ADDENDUM
NO. 3

July 31, 2020

Additions & Renovations to Lawrence North High School
7802 Hague Road
Indianapolis, IN 46256

PREPARED BY SCHMIDT ASSOCIATES FOR:
LAWRENCE NORTH HIGH SCHOOL RENOVATION
LAWRENCE TOWNSHIP, M.S.D. OF

P. **Drawing Number E-401.**

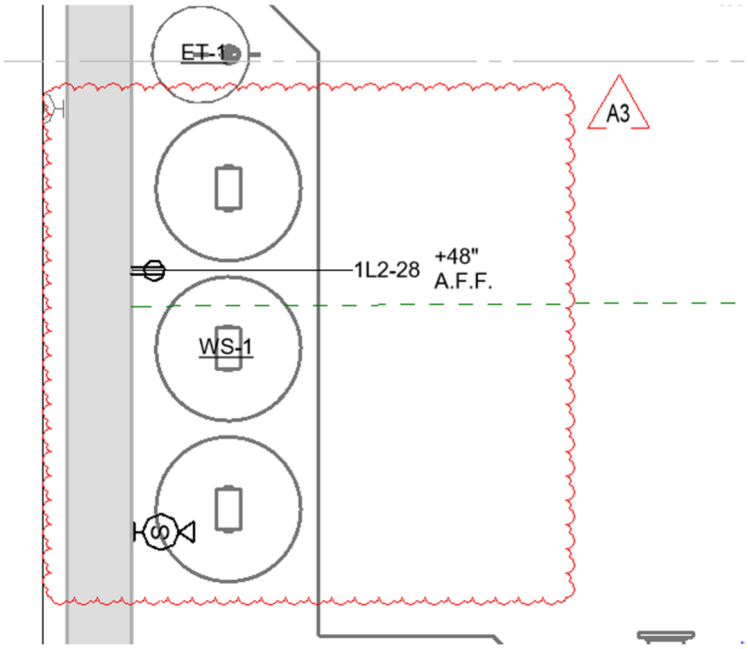
4. Add dedicated circuit duplex receptacle behind water softeners as shown below. Provide 20A GFCI breaker.

R. **Drawing Number E-604**

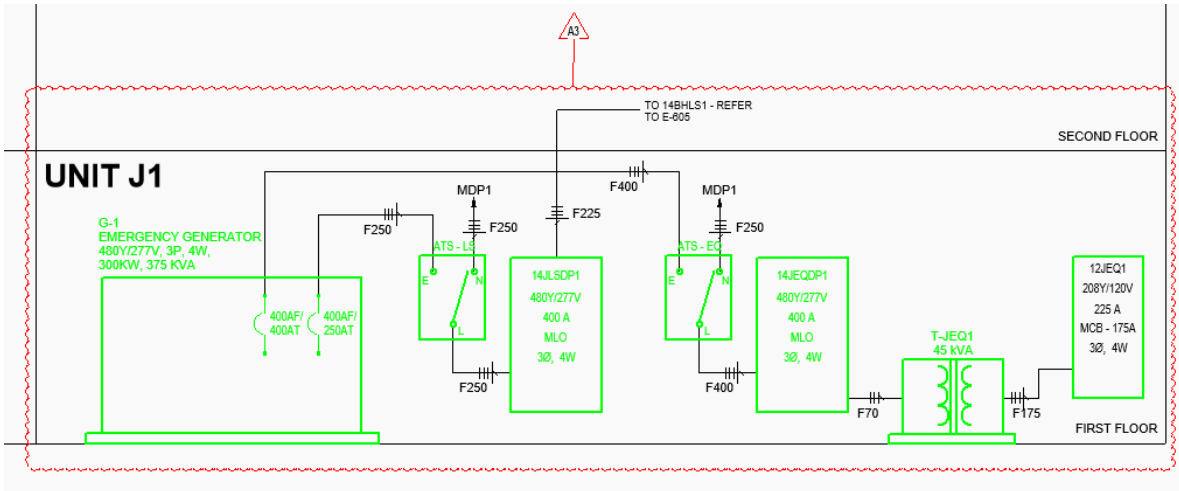
2. Partially replace the emergency one-line diagram as shown below:
